Appeals Convenor's Report to the Minister for Environment

Appeal objecting to Report and Recommendations of EPA
Report 1716 – Revised Proposal for the Roy Hill Iron Ore Mine

Appellant	Conservation Council of WA Inc
Proponent	Roy Hill Iron Ore Pty Ltd
Authority	Environmental Protection Authority (EPA)
Appeal No.	050 of 2021
Date	April 2022

Figure 2 Interim Emissions Targets - Scope 1 emissions (Revised Proposal)¹⁰

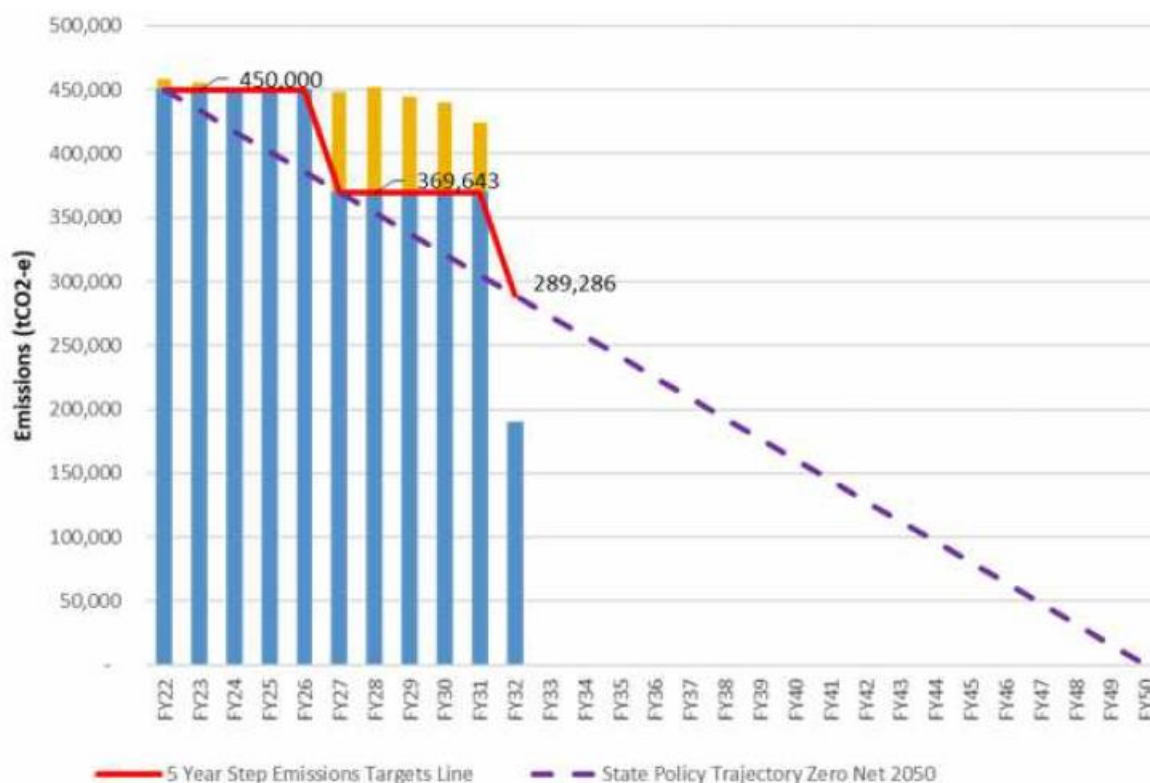
Condition 9 recommended by the EPA includes a limit in scope 1 GHGe based on five-yearly intervals. Cumulatively, the scope 1 emissions contemplated under condition 9-1 is 4.39 Mt CO₂-e. This is approximately 190,000 tonnes higher than the 4.2 Mt referenced in Report 1716.

On further analysis, it also appears that the 5.1 Mt CO₂-e unmitigated scope 1 emissions quoted in Report 1716 does not correspond to the proponent's estimated emissions for the 11 years ending 30 June 2032: on that analysis, unmitigated emissions are calculated to be 4.7 Mt CO₂-e. It appears the 5.1 Mt may be an artefact of the proposal being intended to commence a year earlier (financial year 2021) but which is not reflected in condition 9-1.

Taking the above into account, it appears the mitigation levels contemplated by recommended condition 9-1 are in the order of 318,000 tonnes CO₂-e. This is about one third of the emissions reductions of approximately 900,000 tonnes identified by the EPA.

As discussed above, the EPA advised that emission reduction initiatives proposed by the proponent will result in reduced estimated scope 1 GHG emissions to 4.2 Mt of CO₂-e over the life of the mine⁸ (2021 to 2032), down from the estimate of 5.1 Mt of CO₂-e listed in the proponent's ERD.⁹ Figure 2 (below) shows RHIO's proposed trajectory of scope 1 GHGe for the projected LOM using these figures.

We recommend that the appeal be allowed in part by amending condition 9 to require a review of the GHGMP within 12 months of any approval of the proposal under section 45 of the EP Act. The review to include confirmation of average and total scope 2 emissions to effectively measure benchmarking of GHGe intensity for comparison purposes.
